### **REMARKS**

The applicant has had an opportunity to carefully consider the Examiner's Office Action of March 26, 2003 and believes this amendment is fully responsive to every point raised by the Examiner. Reconsideration of the application, as amended is respectfully requested. Claims 1-20 remain in the application after this amendment is entered.

### **THE OFFICE ACTION:**

Figure 3

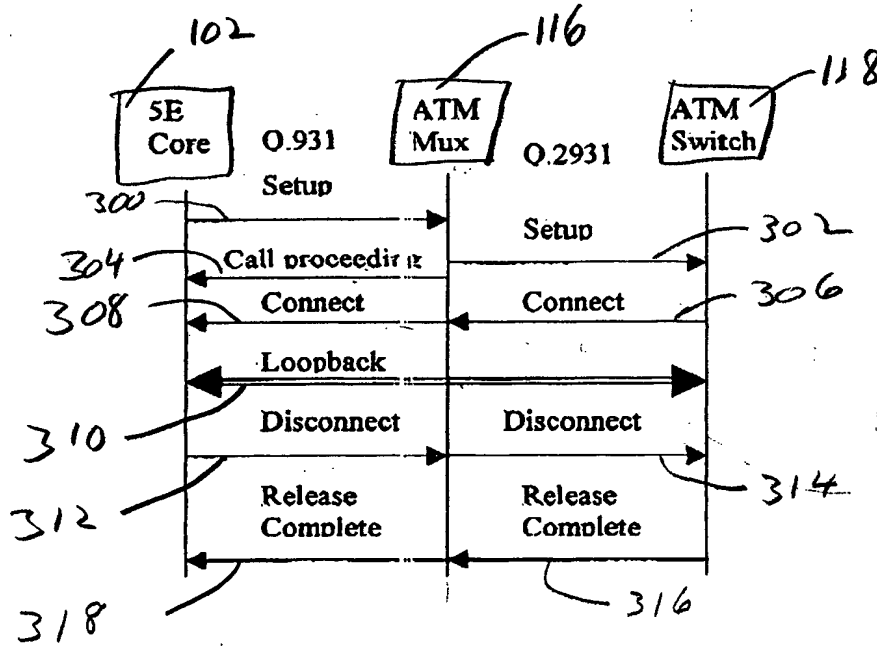
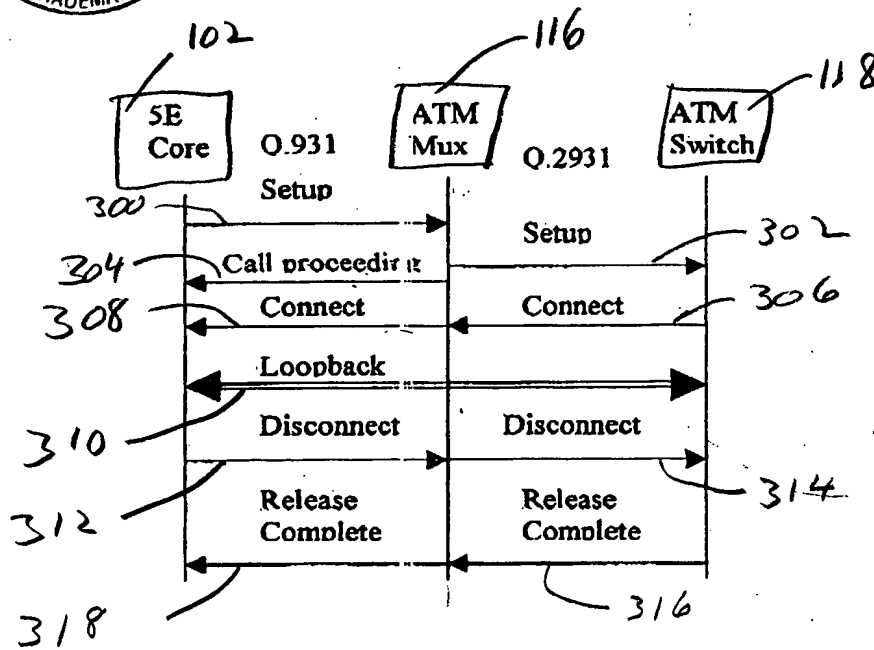
Claims 3 and 14 have been amended to recite that the interwork unit provides an IPDC capability. Fig. 3 shows Q.931 messages communicated between the 5E core 102 and the ATM multiplexer 116. The originally-filed specification identifies

that Internet Protocol Device Control (IPDC) may be used for these communications instead of Q.931 (see page 9, lines 13-16). Hence, the drawings show the IPDC feature of the invention specified in the claims.

Change 116 to 112.  
 Delete "modem pool" text.  
 Add block 117 inside block 112.

Figure 4

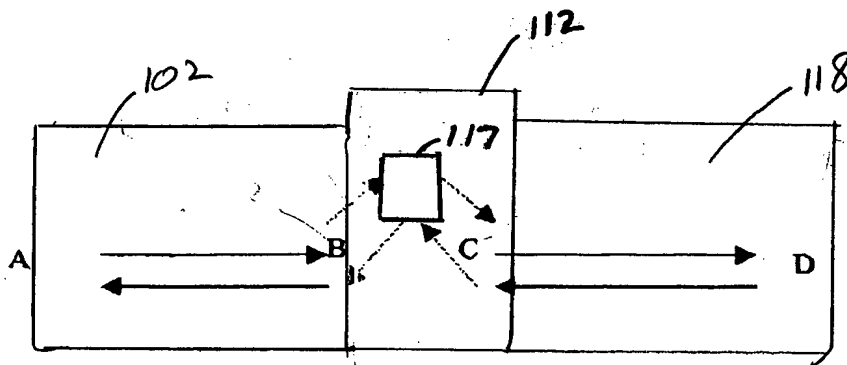
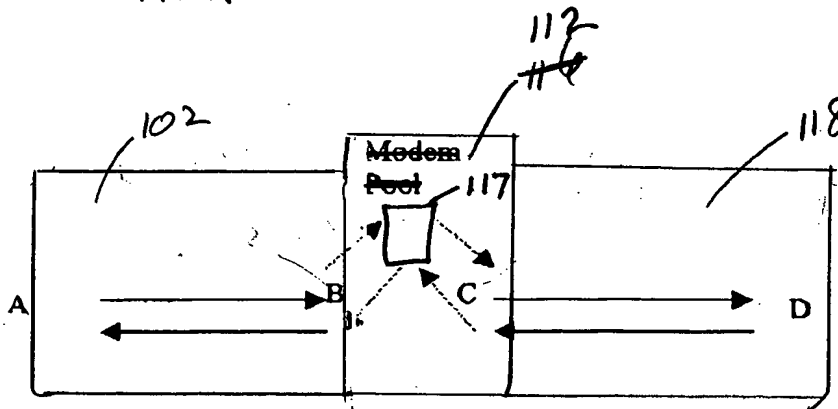
The originally-filed specification identifies the IP router 112 and its routing table on page 11, lines 22-25. The originally-filed specification also stated that the IP router, as illustrated in Fig. 4, is one embodiment of the packet switching gateway 113. As amended, Fig. 4 now identifies the IP router 112 and routing table 117 as identified and described in the originally-filed specification. Hence, the drawings show the routing table feature of the invention specified in the claims.
